ORDINANCE 94-29

TO AMEND THE BLOOMINGTON ZONING MAPS FROM SI to RL,
GRANT PUD DESIGNATION, AND APPROVE OUTLINE PLAN
Re: 1730 N. Range Road
(Regency Associates, Petitioner)

**FOUNTAIN PARK EXPANSION
RL/PUD
OUTLINE PLAN STATEMENT**

BLOOMINGTON PLAN COMMISSION
PRELIMINARY STAFF REPORT
Location: 1730 N. Range Road, Bloomington, IN 47401

SITE PLAN
 SCALE: 1" = 80'

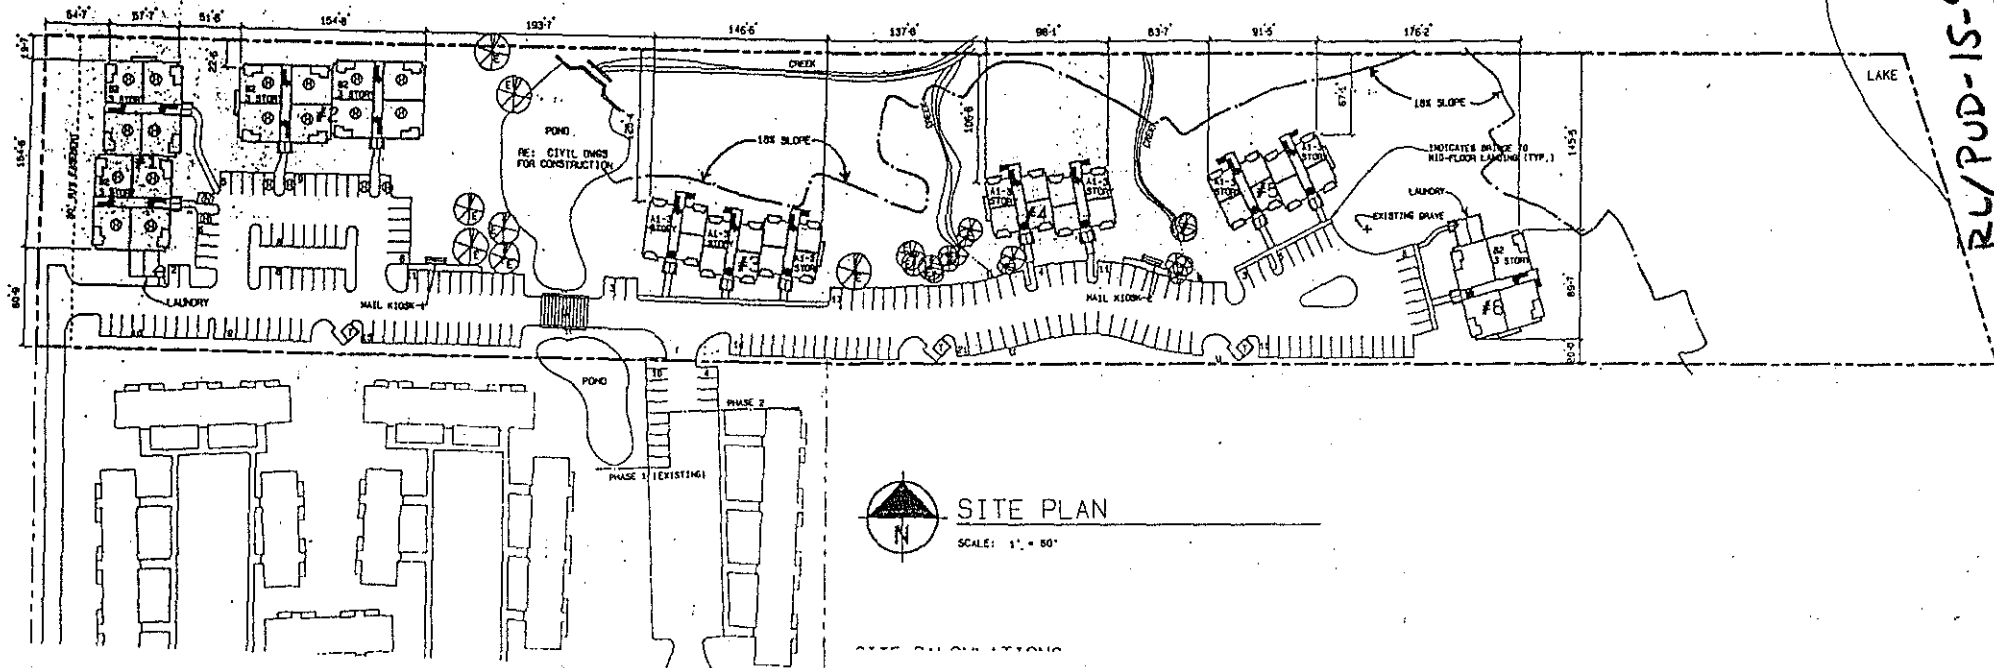
1. shifting the location of building #3 to a position where it avoids 18 percent slopes. The new slope of building #3 is a much more preferable 10 percent.

2. increasing the number of efficiency units (at the expense of 2-bedroom units) from 72 to 84. This reduces both the total building footprint area on the site and the impervious area needed for parking.

3. slightly reducing the amount of vegetation disturbance on the site. Shifting the location of building #3 and changing its footprint will prevent approximately 30 percent less vegetation from being disturbed in that area.

4. shifting the location of buildings away from more sensitive soils. Caneyville soils, which are given severe ratings in the Monroe County Soil Survey for all types of building site development, are located on the 12-18 percent slopes of this site. Since the steepest building site has now been reduced to approximately 14 percent, a greater percentage of buildable area will fall on more stable Crider silt loam soils.

5. adding extra erosion control protection at points where concentrated water runoff could lead to washouts of erosion control barriers. Secondary fencing will now have extra stakes or a woven wire backing to protect concentrated flow areas from heavy stormwater runoff.
